Appliance Standards Awareness Project
American Council for an Energy-Efficient Economy
Natural Resources Defense Council

RE: Docket Number EERE–2017–BT–TP–0012/RIN 1904–AD47: Notice of Proposed Rulemaking for Test Procedures for Room Air Conditioners

Figure 1. Percent Increase in Efficiency of Weighted-Average EER Relative to 95°F EER

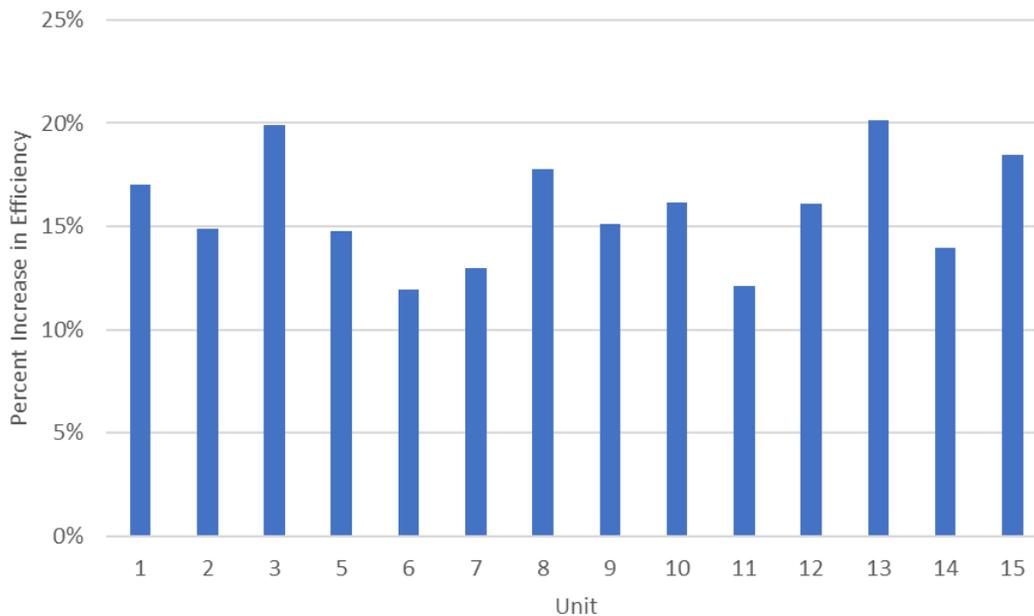
Figure 1 shows the percent increase in efficiency of the weighted-average EER relative to the 95°F EER for each unit. While the weighted-average EERs of all the units are higher than their respective EERs at 95°F as expected, the data show that different room AC units respond differently to the lower temperature conditions. Specifically, the increase in the weighted-average EER relative to the 95°F EER ranges from 12% to 20%. The impact of this range of lower-temperature performance can be seen, for example, with Units 3 and 6. As shown in Table 1, while both units had a tested EER of 11.7 at 95°F, Unit 3 has a weighted-average EER of 14.0, while Unit 6 has a weighted-average EER of 13.0.

In addition, a load-based test would better reflect the real-world operation of both single-speed and variable-speed units. For single-speed units, a load-based test would capture the impact of cycling losses. In the NOPR, DOE proposes to use assumed cycling loss factors ranging from 0.875 at the 82°F condition to 1.0 at the 95°F condition as part of the calculation of the “performance adjustment factor” for variable-speed units,¹⁵ but these cycling losses are not captured for single-speed units. Furthermore, we would expect that cycling losses may vary among individual single-speed units, but the current test procedure provides no way to reflect this potential differentiation. For variable-speed units, load-based testing would capture the impact of control strategies that determine compressor and fan speed operation and would ensure that the test procedure reflects the real-world operation of these units. We appreciate the investigative load-based testing that DOE conducted for the NOPR, and we encourage DOE to investigate how a future test procedure could address the challenges associated with load-based testing.
